Subject: Answers to Councilmember Cape's questions on steep slopes

Mayor Bellamy and City Council Members:

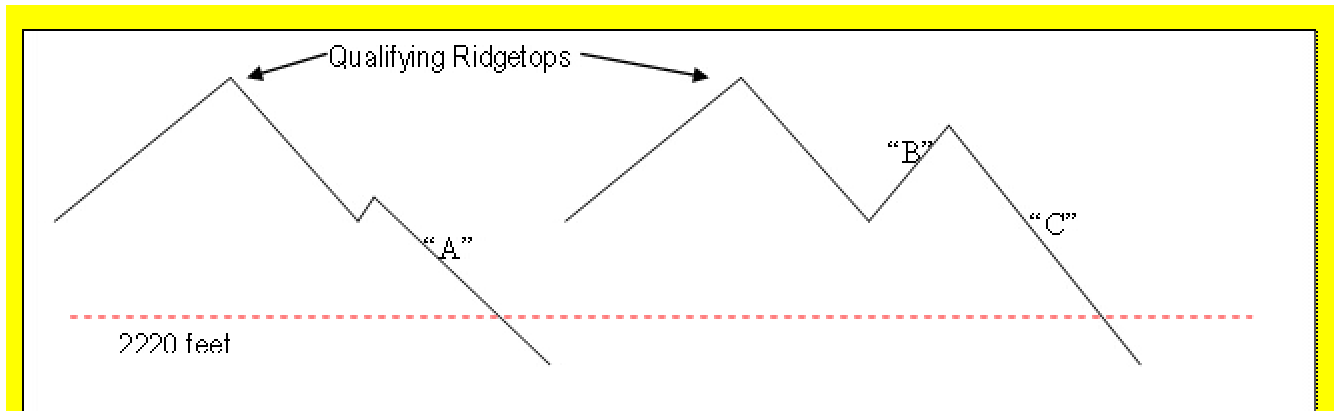
1) please give us a copy of the "official city of Asheville Ridgetops Map

The "official" maps are paper and can't easily be disseminated but I've attached a jpg-file that illustrates the designated ridgetops. After you open the attachment, you will need to zoom in to see the specific ridgetops.
